Technical change to FTA-C300

PCN-number: 20210517

2. Technical change

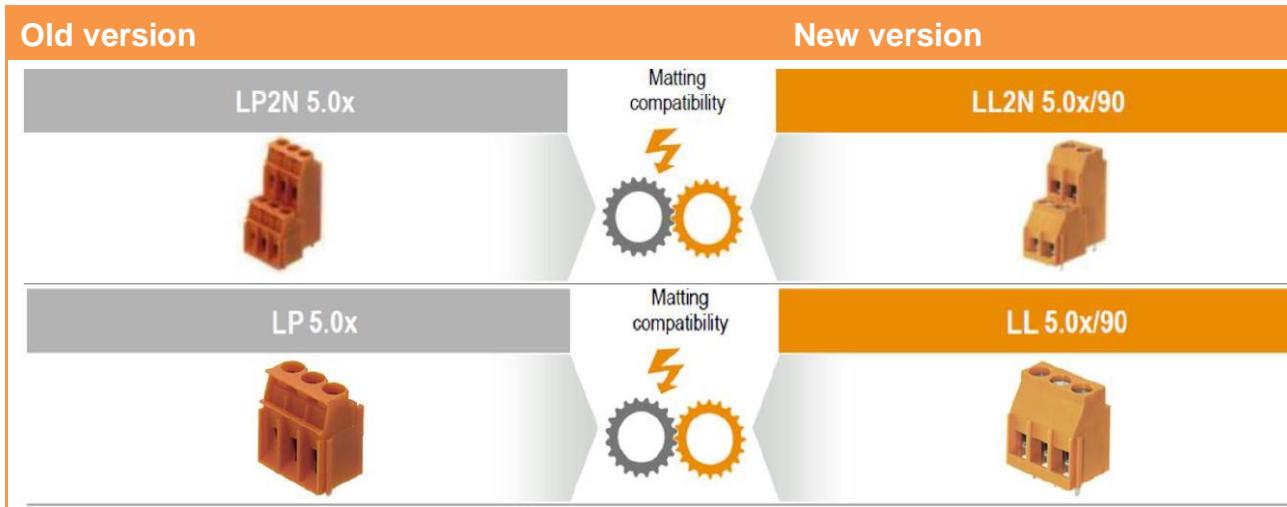
Articles on Section 5 were delivered in the past with LP and LP2N connectors. Furthermore, they were delivered with Dekafix*

Based on continuous improvement the LP and LP2N connectors will be replaced by LL and LL2N connectors with Tampoprint.

Obsolescence of LP and LP2N connector range and addition of **UL-recognized** approvals (cULus) on the label for these products, making each interface UL recognized.
